September 25, 2024
Planning
Commission Special
Meeting
Information Packet

Consideration of the proposed PUD for the Deseret Meadows (formerly Deseret Commons) subdivision, located at approximately 1079 W. Hwy 112, including the consideration of the concept plan and variance table.

**Staff Report Summary for
Deseret Meadows Planned Unit Development**

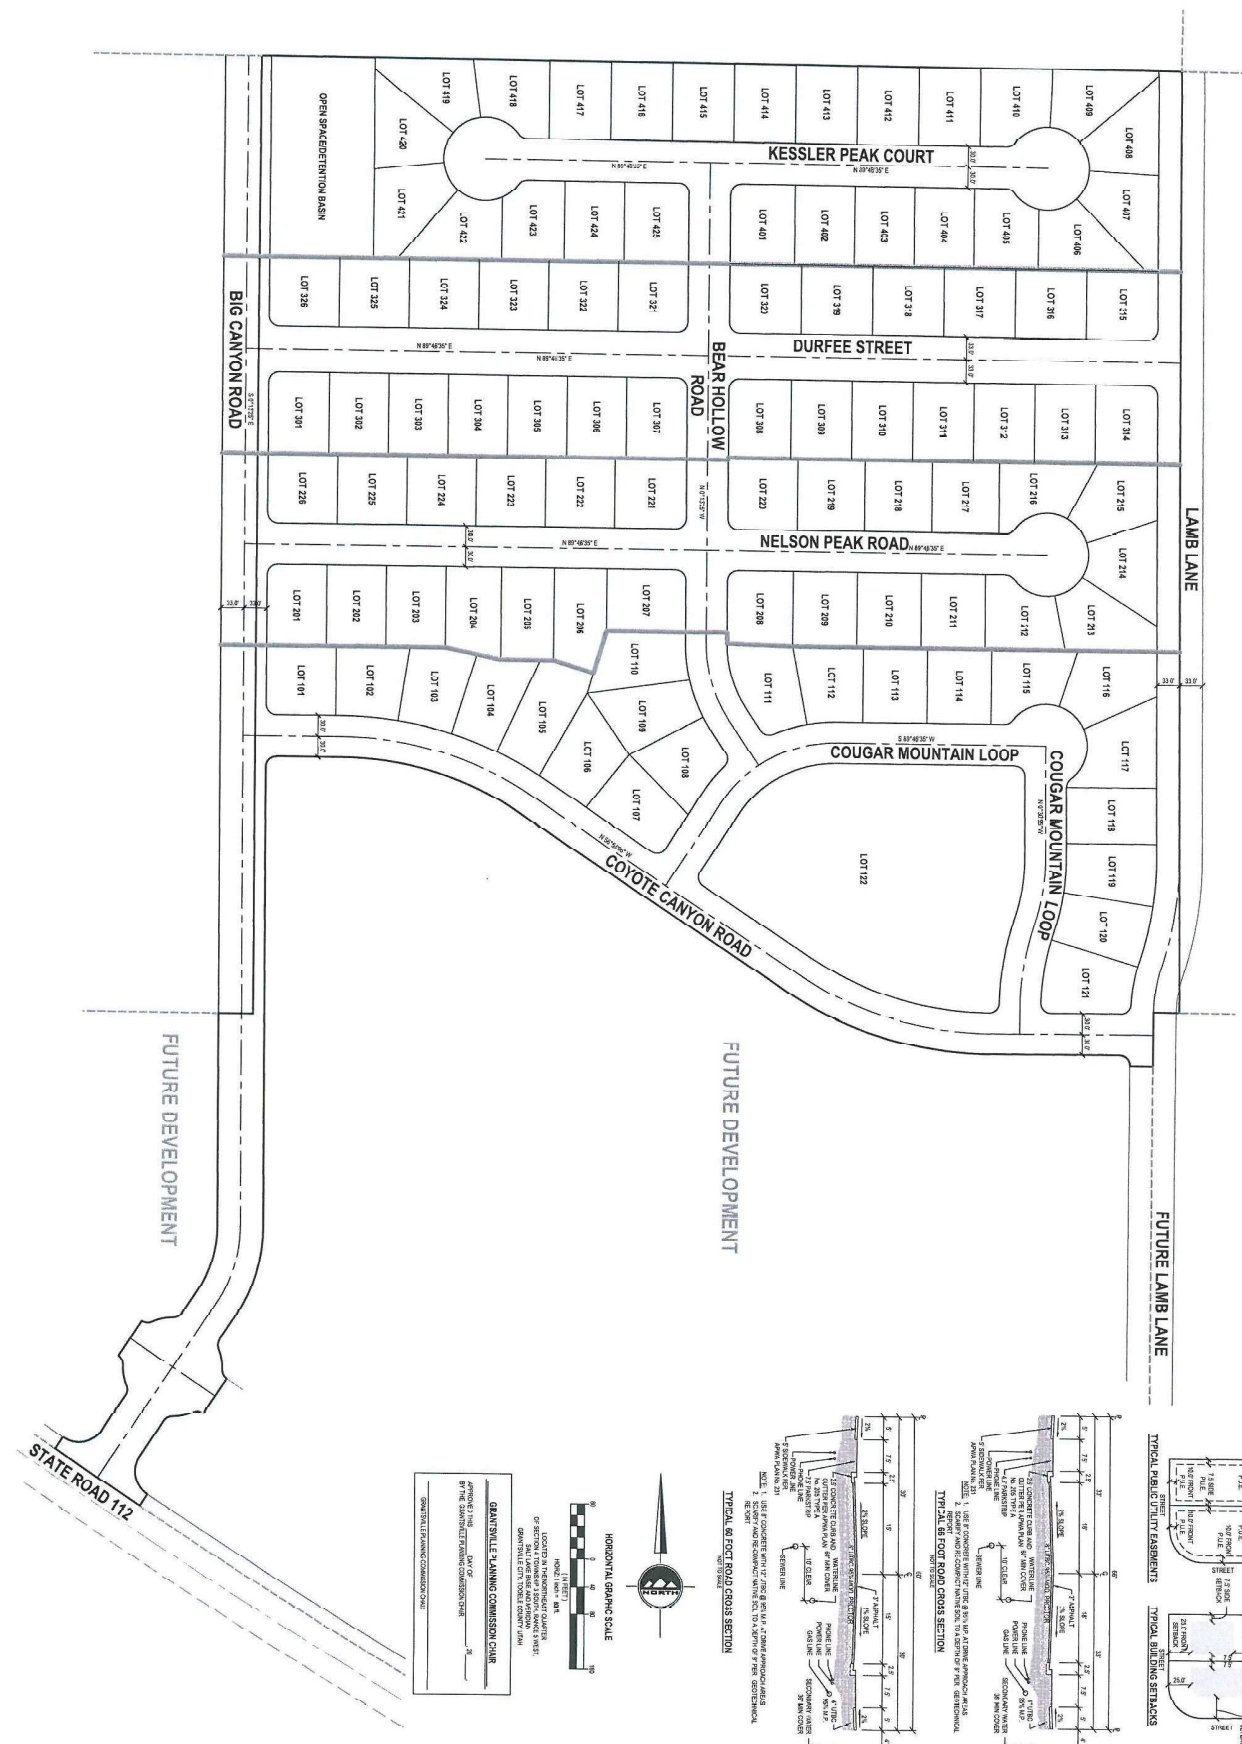
All setbacks and easements as shown on Sheet C-300 conform to the zoning requirements for the RM-15 Zone. All lots meet the minimum area requirement of 8,000 square feet for interior lots and 10,000 square feet for corner lots. All lots appear to meet the minimum width and frontage requirements for the zone.

1. "A vicinity map showing significant natural and man-made features off site with a scale of 1 inch = 2000 feet on the site."
Show vicinity map with a scale of 1 inch = 2000 feet.
2. "Topographic contours,"
Contours are incorrectly labeled. The elevations should read in the range of 4300 feet to 4350 feet.
3. "The acreage of the entire tract and the acreage of the portion to be developed,"
Sheet C-100 shows 39.46 total acreage and C-200 show 41 total acreage.

4. Revise the typical cross-sections and notes on Sheet C-300 to provide 6" thick sidewalk on 6" UTBC and 3" of AC pavement on 6" of UTBC on 8" of Granular subbase

5. Revise the typical cross-section on Sheet C-300 to conform to the typical cross-section in the Street Master Plan.
6. Revise the typical cross-sections and notes on Sheet C-300 to provide 6" thick sidewalk on 6" UTBC and 3" of AC pavement on 6" of UTBC on 8" of Granular subbase
7. Big Canyon Road is shown as a partial improvement only. Recommend that this street be improved to its full width with this Project.
